PINEBROOK 2 (GR) ELEV. - 1, 2, & 3

7	
6	
5	
4	
3	NOV. 1, 2018 REVISED TO ENERGY STAR REISSUED FOR BUILDING PERMIT
2	NOV. 30, 2017 ISSUED FOR BUILDING PERMIT
1	OCT. 19, 2017 ISSUED FOR ROOF AND FLOOR TRUSSES

BASEMENT PLAN EL-1
 SECONDO VALES ESTATES
 EAST GWILLIMBURY

FIRST FLOOR PLAN EL-1
 SECONDO VALES ESTATES
 EAST GWILLIMBURY

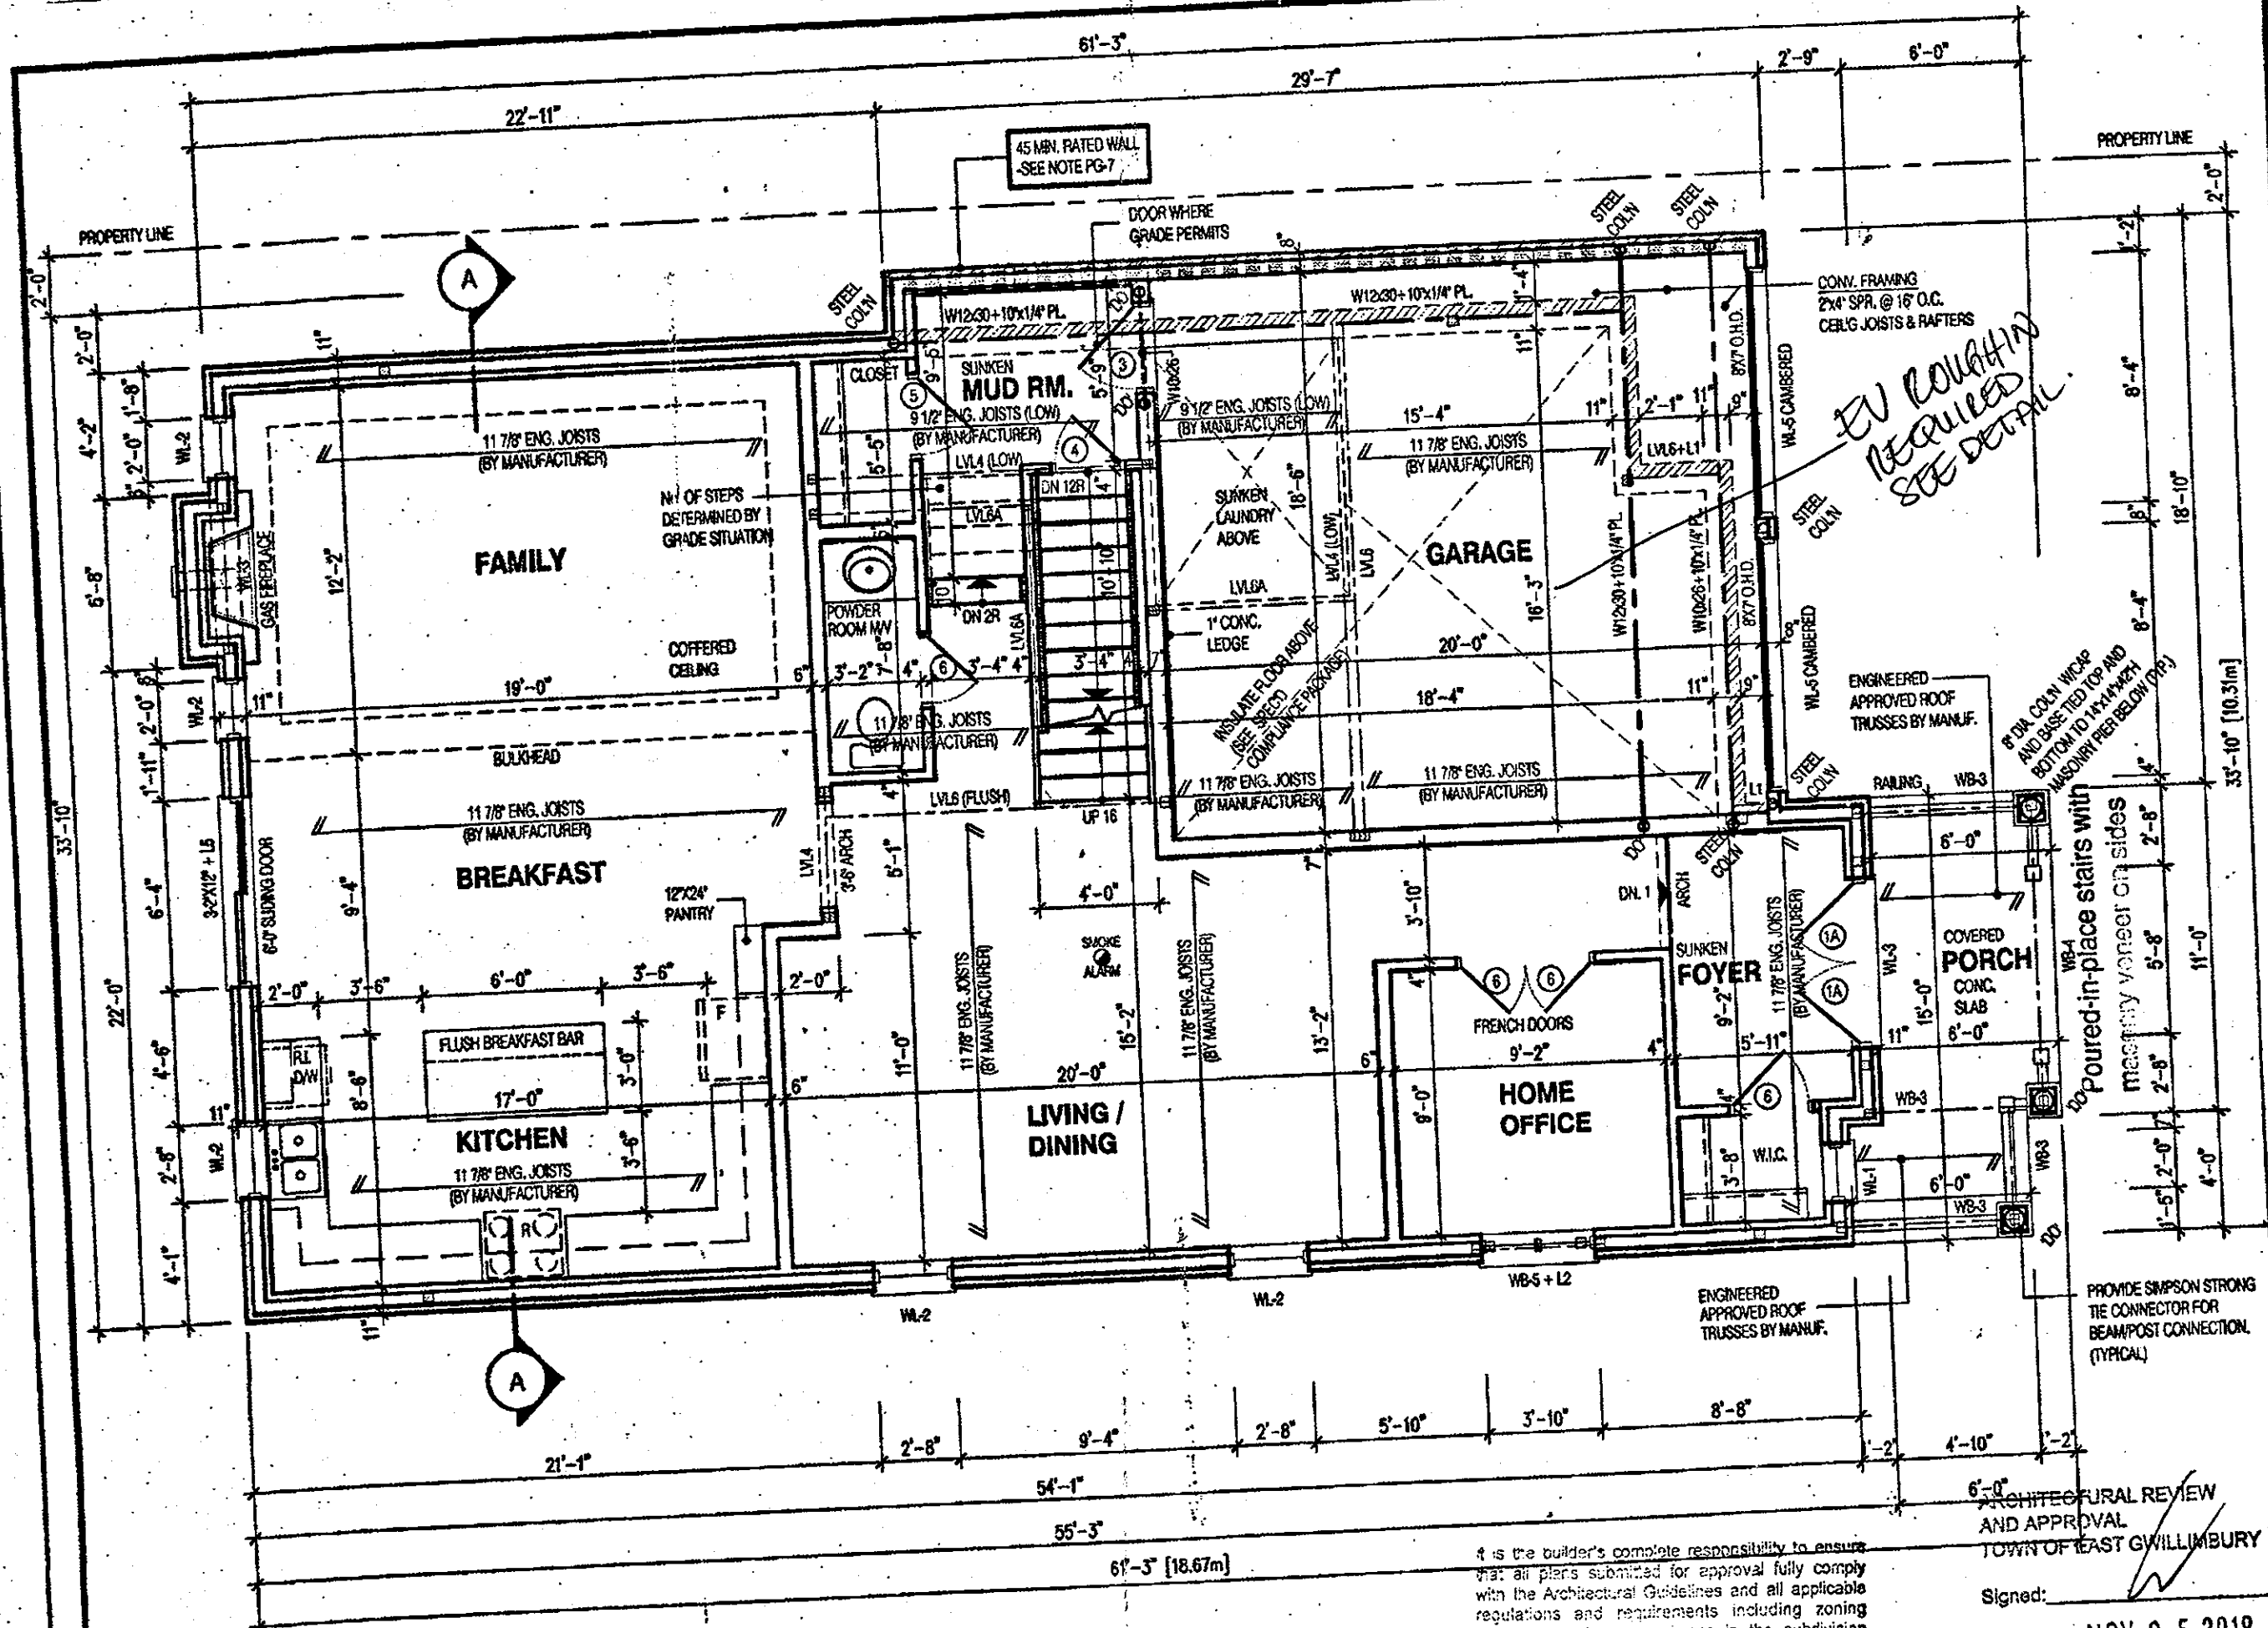
EV COLLATION REQUIRED SEE DETAIL.

poored-in-place stairs with masonry veneer on sides

**PINEBROOK 2
FRONT ELEVATION 1
LOT 23**

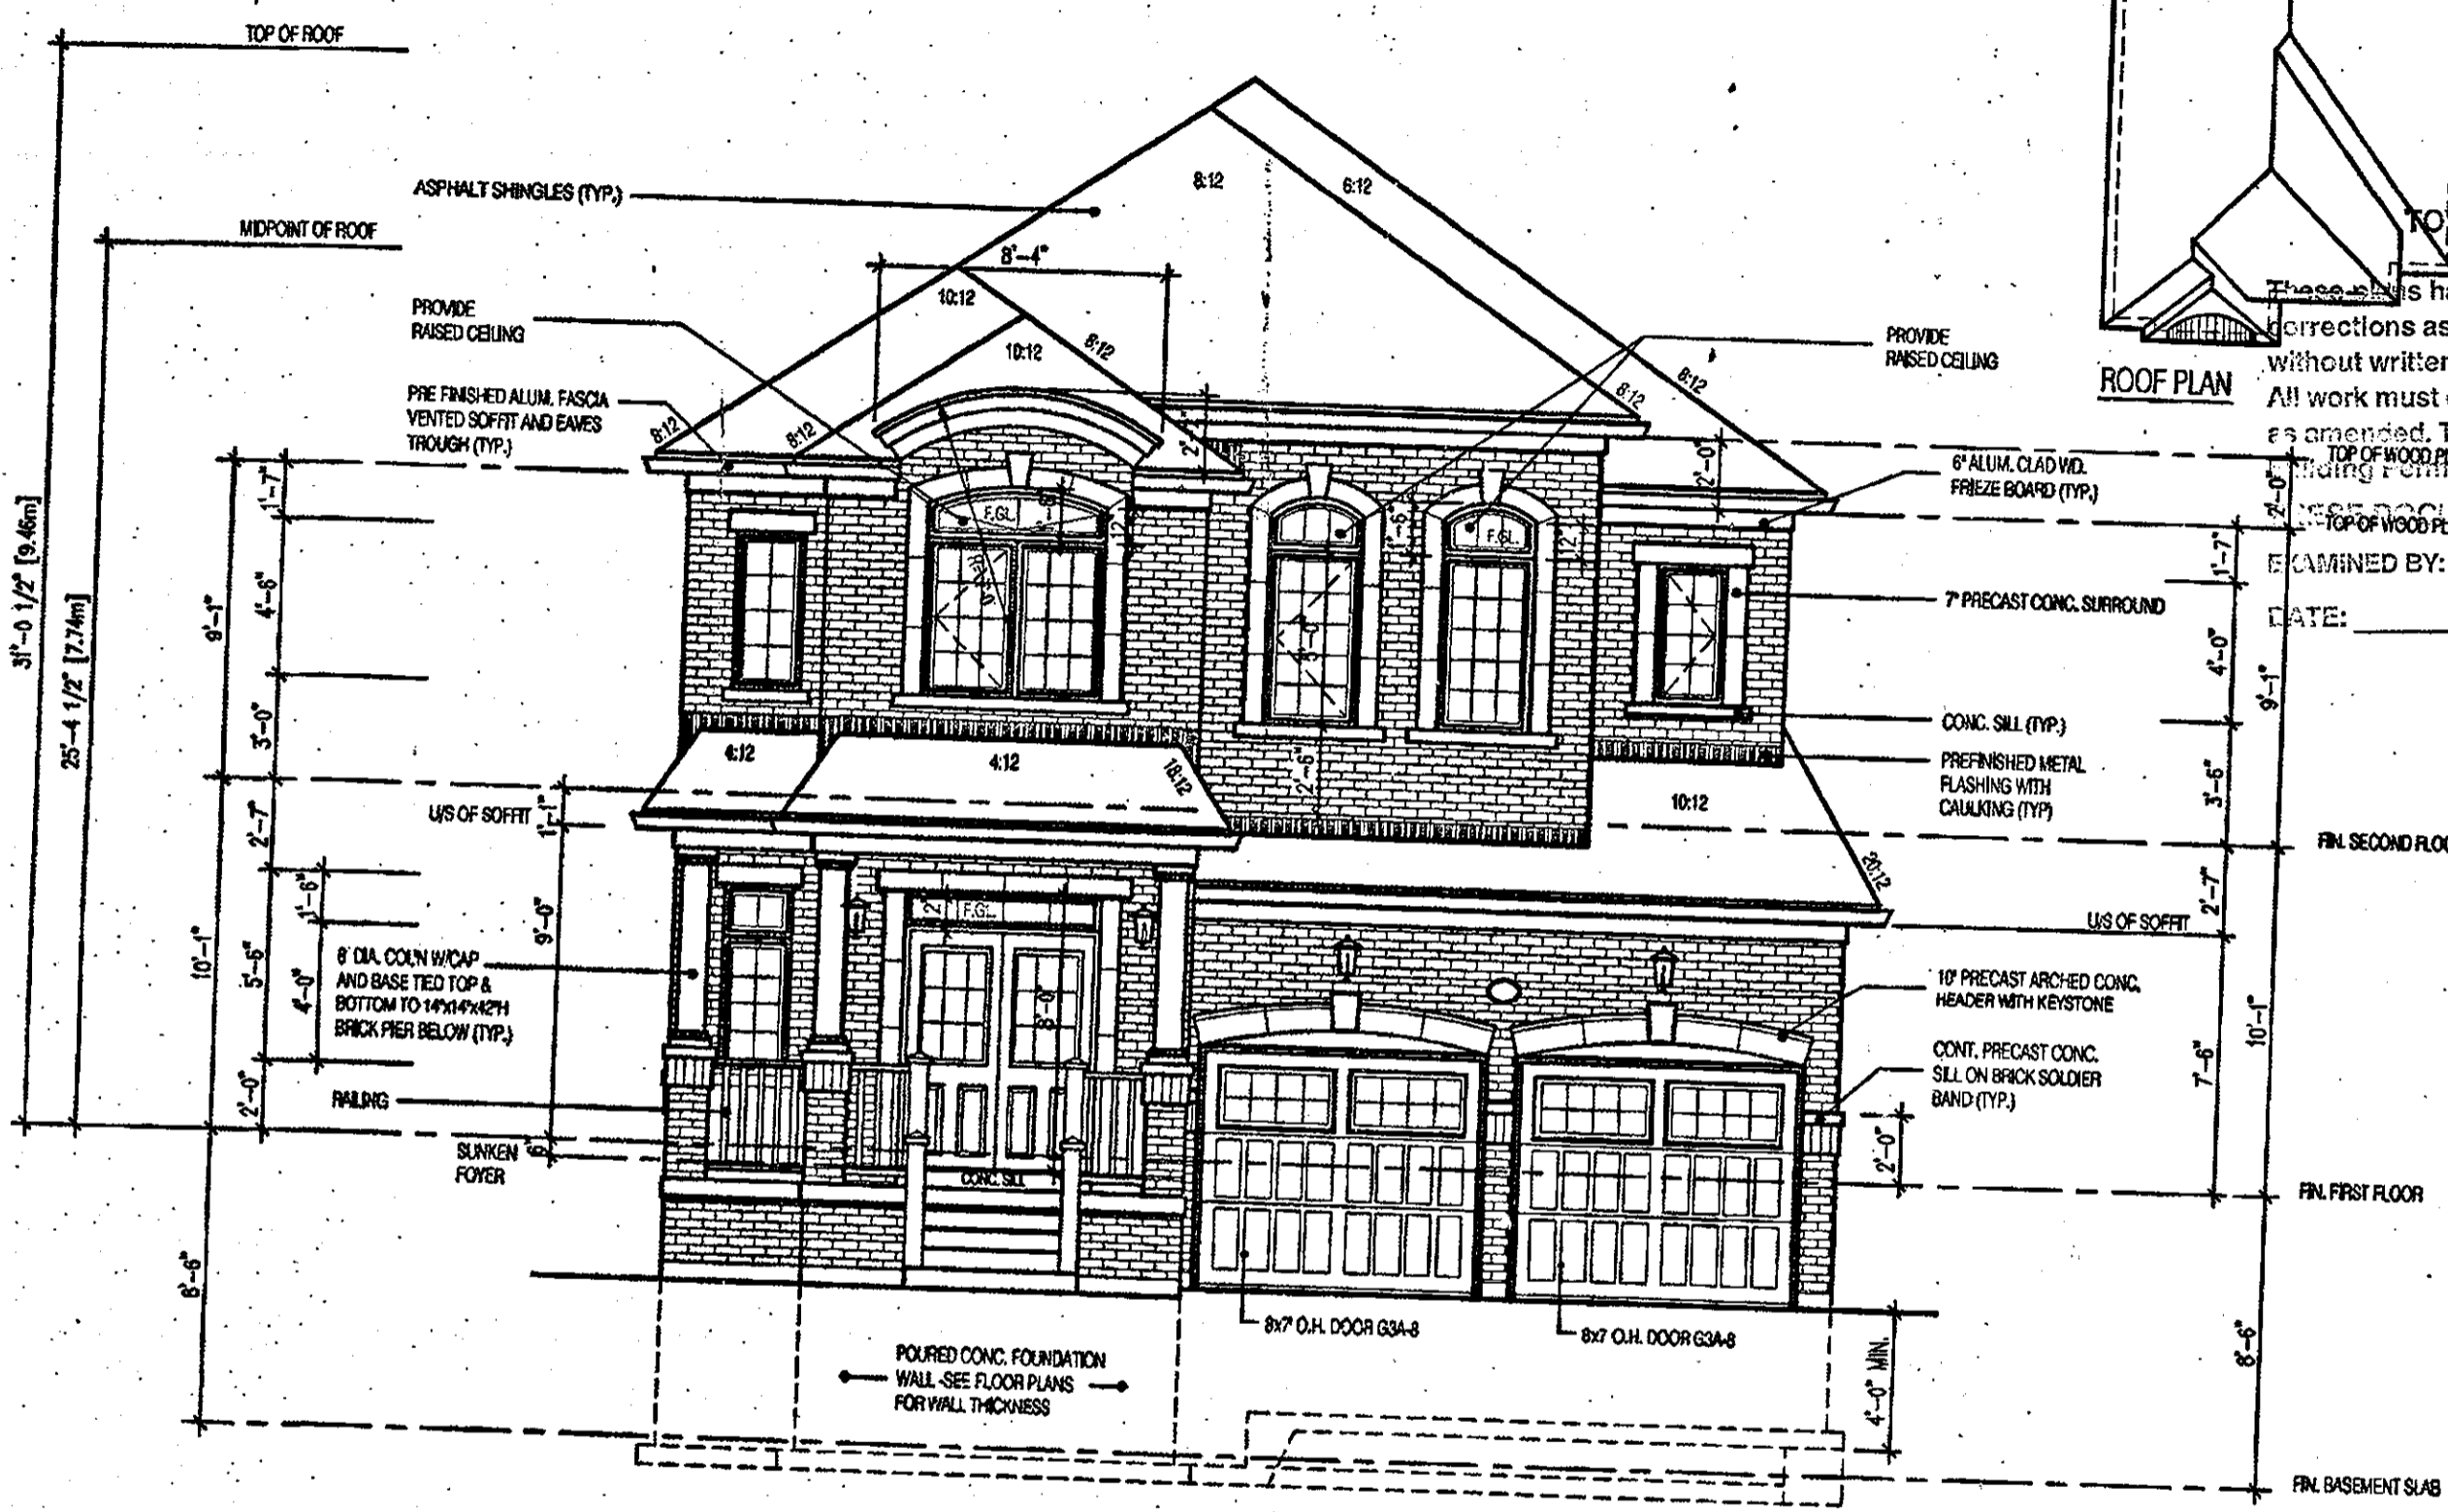
LOT SPECIFIC CHANGES:
 - GARAGE ROOF SOFFIT DROPPED 12"
 - CHANGED GARAGE ROOF SLOPE TO 10:12
